**IMPERIAL METALS CORPORATION  
MT. POLLEY PROJECT**

**RESPONSE TO REVIEW COMMENTS  
ON TAILINGS EMBANKMENT DESIGN  
(REF. NO. 1625/6)**

**JANUARY 25, 1996**

FIGURE 3

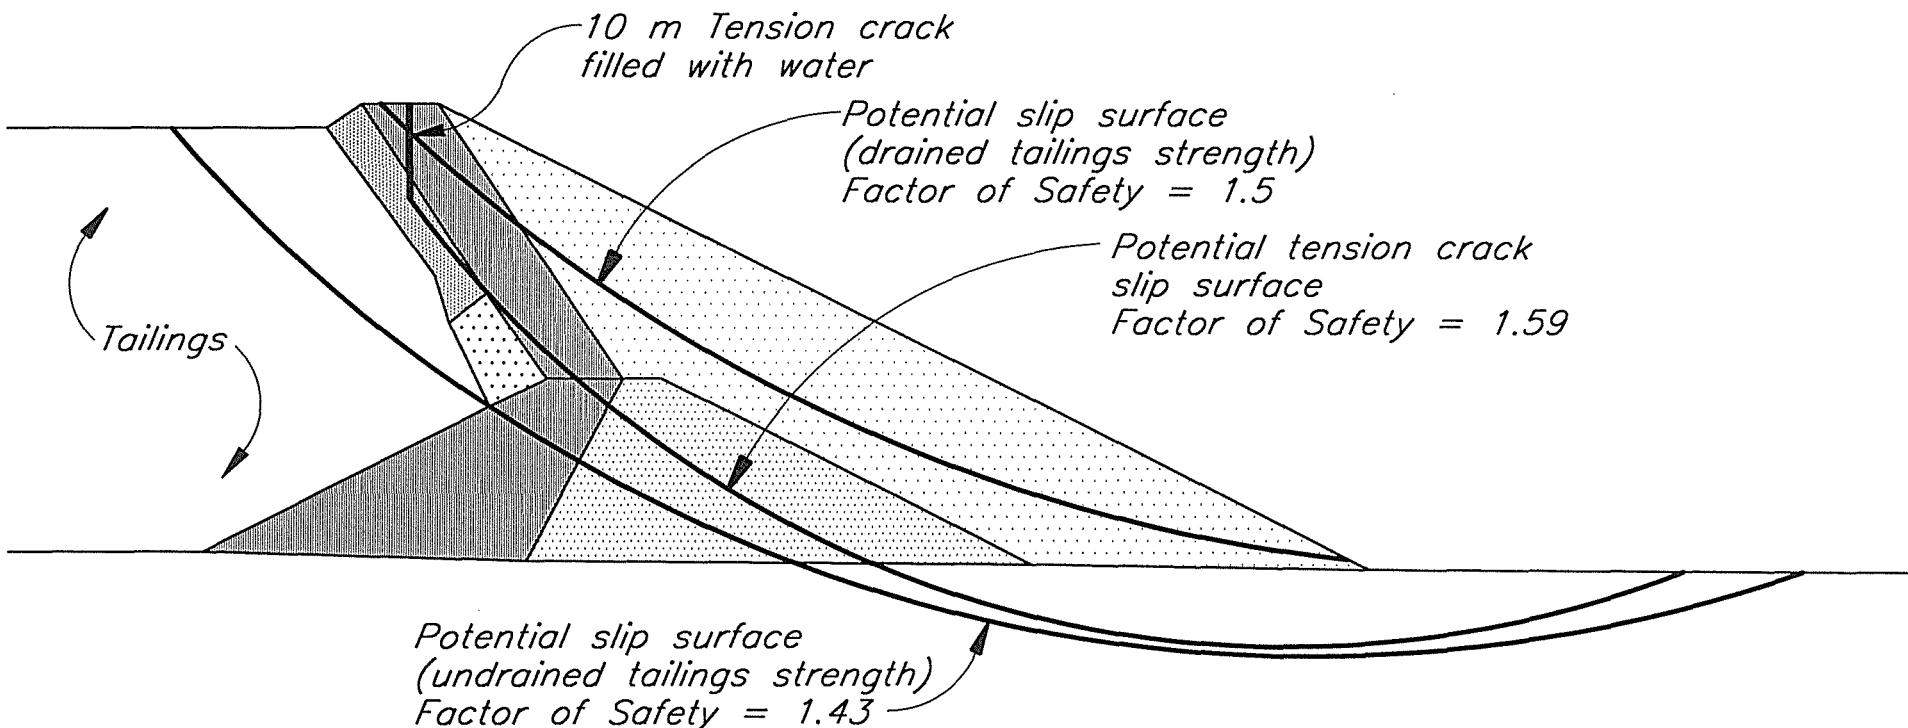
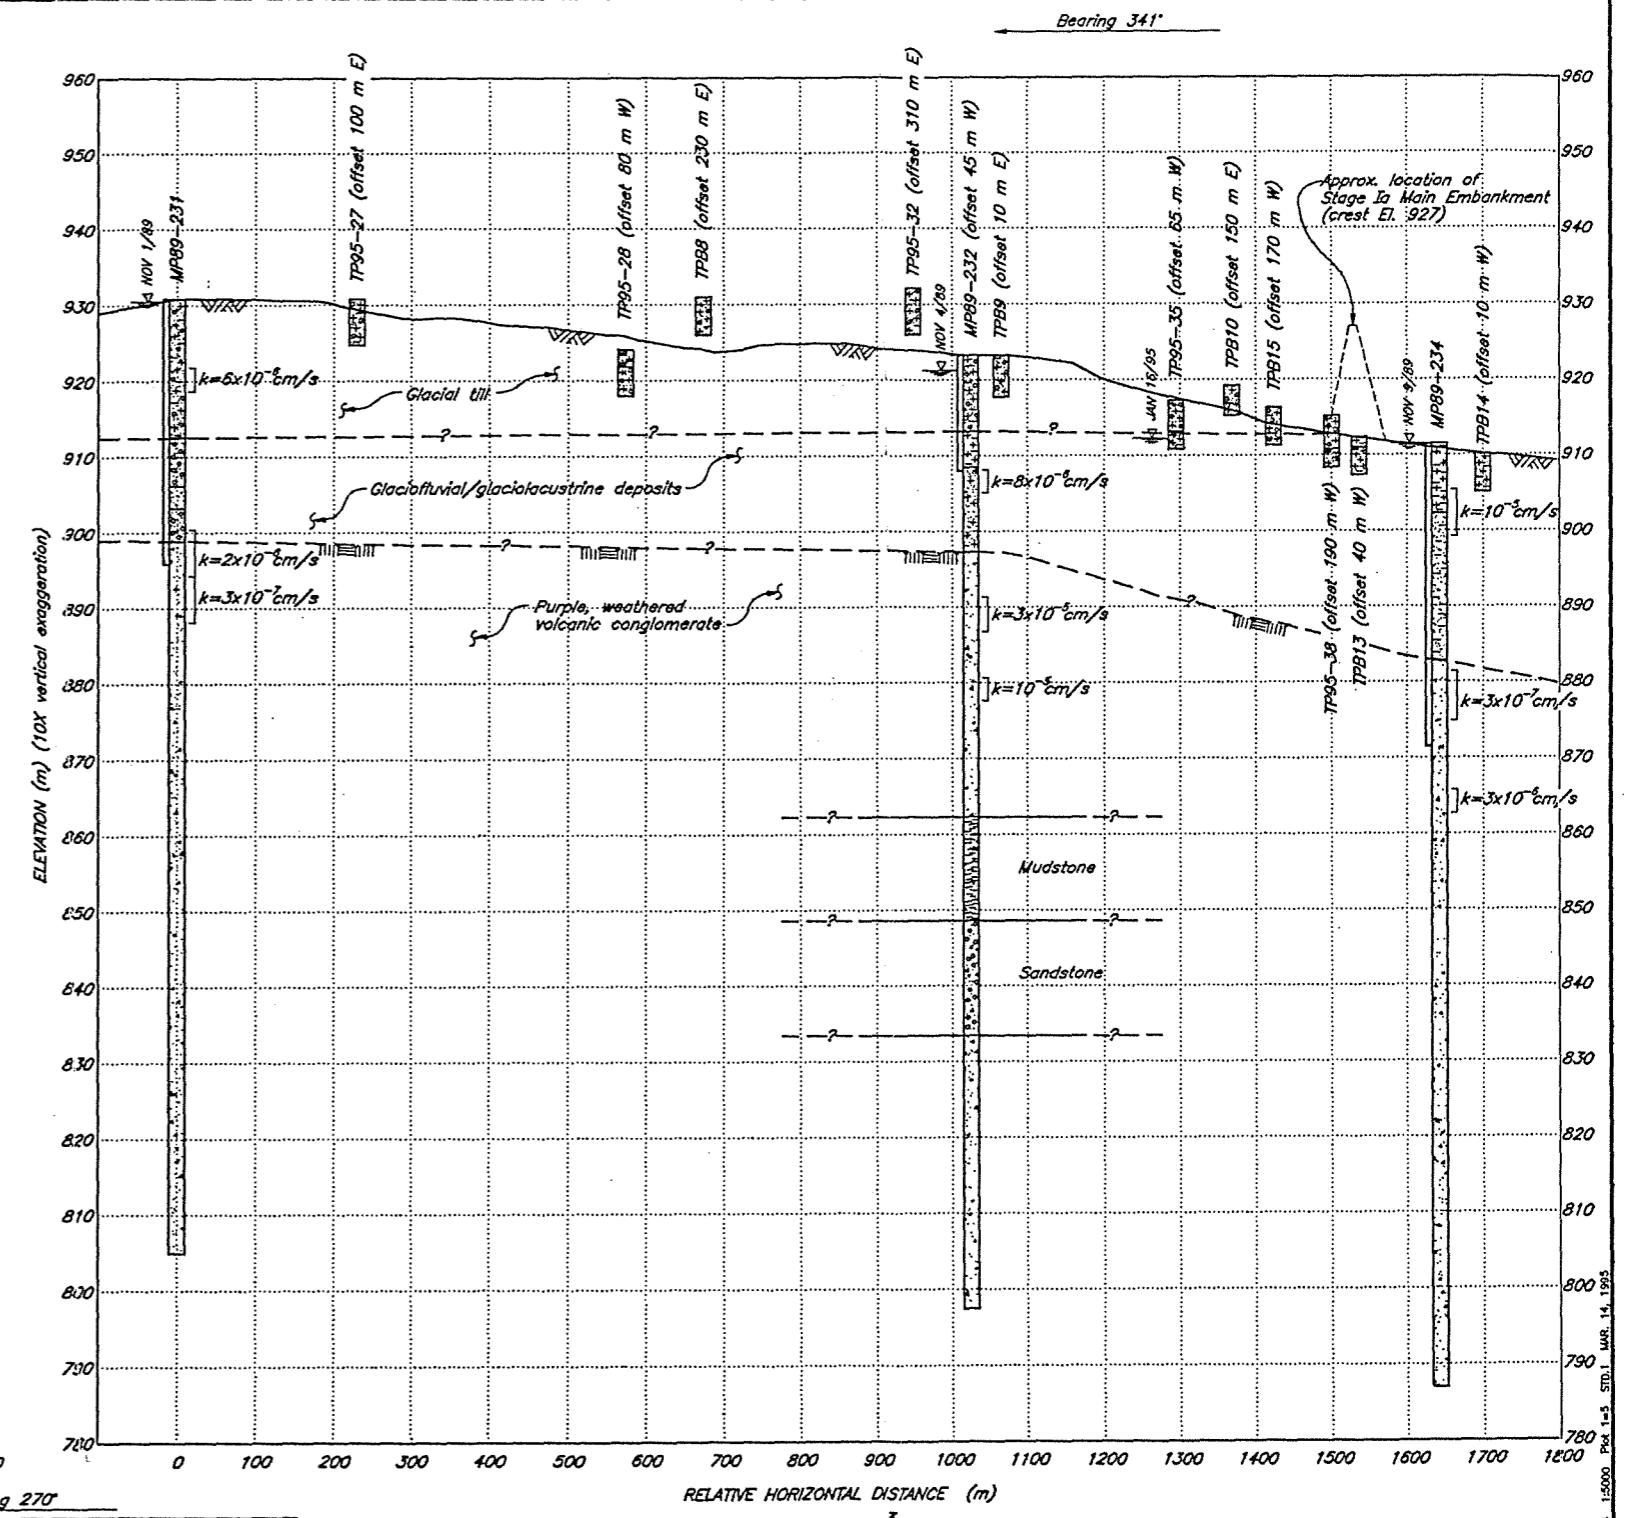
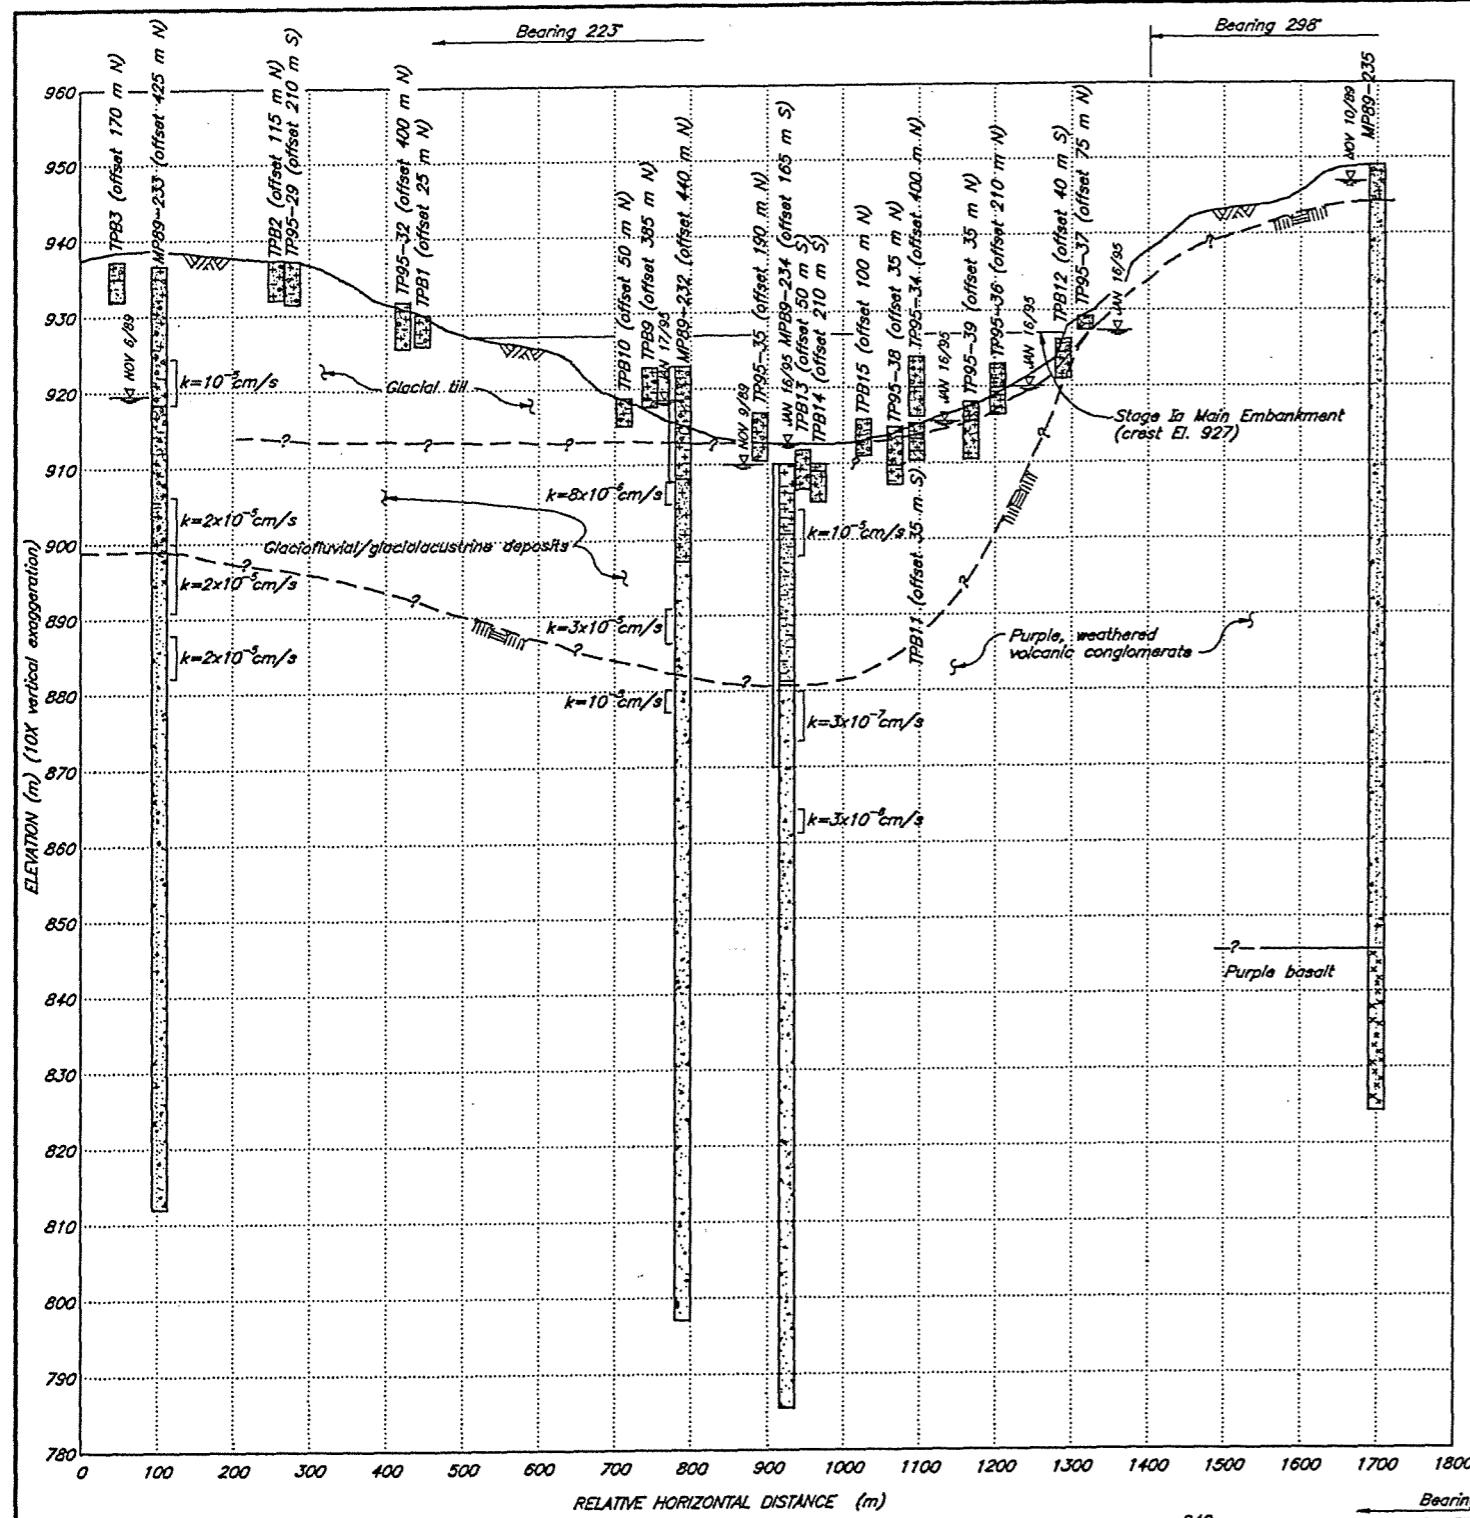
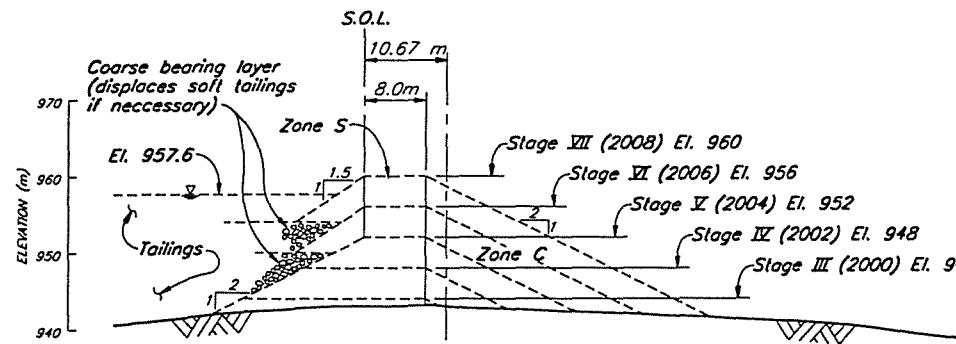
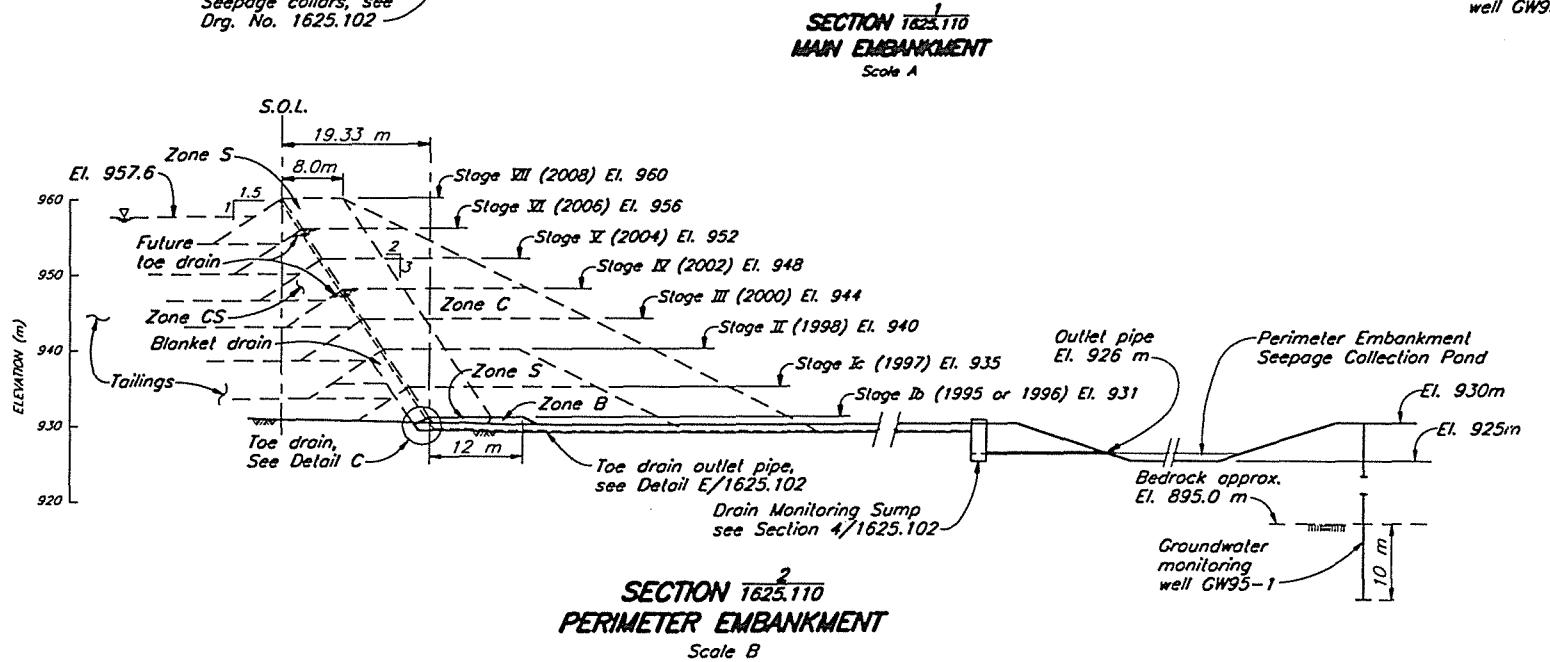
*The design proposed entails some of the compacted main dam to be constructed over loose to medium dense tailings. With this design variability in consolidation characteristics would be expected. This could lead to tension cracks near the top of the main dam and generally parallel to C.L. Stability analysis should allow for 10 m deep tension cracks filled with water.*

Based on our experience with similar construction methods and comparable tailings materials, it is highly unlikely that 10 m deep tension cracks can develop along the crest of the embankment. However, as suggested by Mr. Brawner, stability analyses have been conducted for a 10 m deep tension crack filled with water, as shown on Figure 3. The factor of safety for the water filled tension crack is higher than for the previously reported stability analyses. Therefore, the previously reported minimum factors of safety for the tailings embankment are unchanged even if a 10 m water filled tension crack occurs.

An upstream slip surface for a 10 m water filled tension crack was also evaluated. The results showed that this case is also not critical as the factor of safety is well in excess of 1.5.
